NSLPP MEETING HELD ON 7/04/21

ADDRESS/WARD: 2A Cowdroy Avenue, Cammeray (T)

APPLICATION No: DA 1/21

PROPOSAL: Alterations and additions to a four storey detached dwelling to provide a new replacement roof , a double garage and a carport to Cowdroy Avenue.

Figure 9: Western elevation and LEP building height control

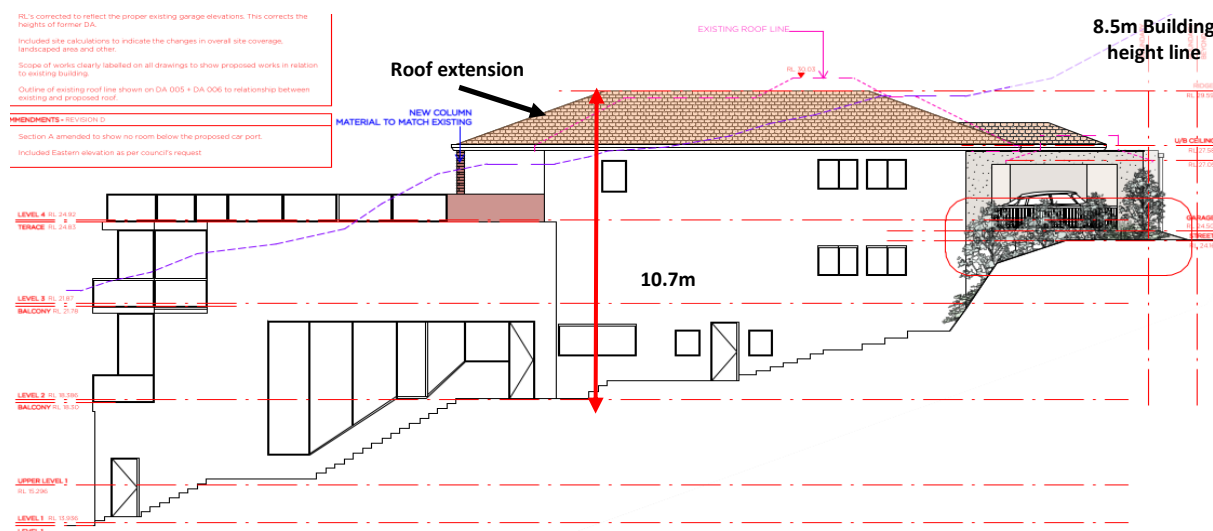
The roof ridge of the existing dwelling has a maximum building height of 10.87m and does not comply with the LEP maximum building height limit due to the sloping landform of the subject site. The proposed roof would reach a maximum height of 10.7m resulting in a non-compliance with the LEP maximum height limit (8.5m) by a maximum of 2.2m as illustrated below (**Figure 9**).

It is also noted that the proposed roof would replace the existing one with an extension to the north by three (3) metres with the creation of a covered area to the north of the Level 4 living area and bedroom as shown in **Figure 9** below.

Figure 13: Views from Level 3 kitchen windows at No.6 Cowdroy Avenue

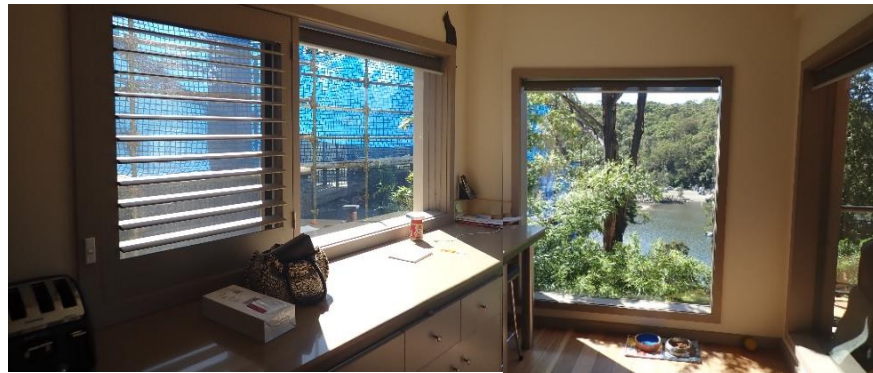
In addition, the view from the Level 3 kitchen window on the western elevation is currently obstructed by the existing dwelling. The proposed roof replacement would not significantly change this outlook apart from a small reduction in the outlook of the sky viewing upwards from this window. Furthermore, the kitchen window on the northern elevation would provide water views along Long Bay and skyline/district views (**Figure 13**).

Figure 14: Foreshore Building Line

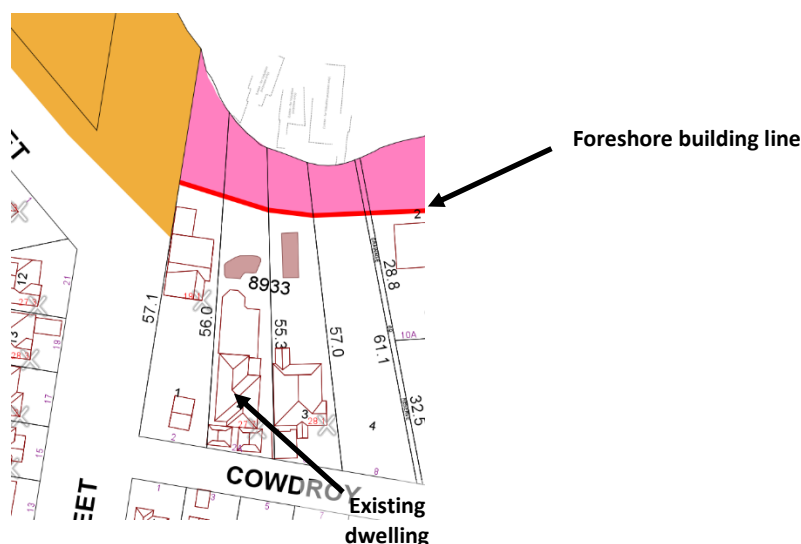
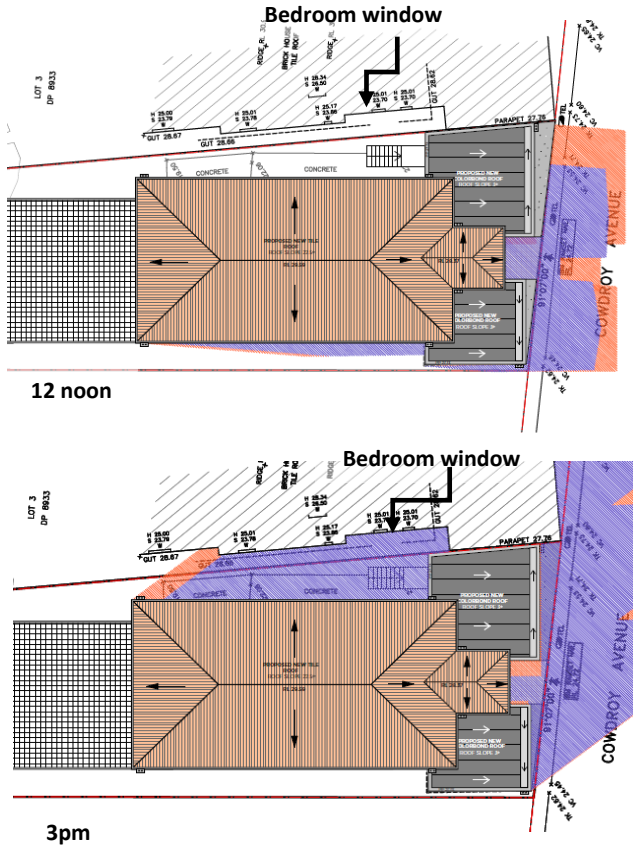
The proposed development does not encroach beyond the foreshore building line because the rear boundary setback of the existing dwelling would be maintained as demonstrated below (**Figure 14**).
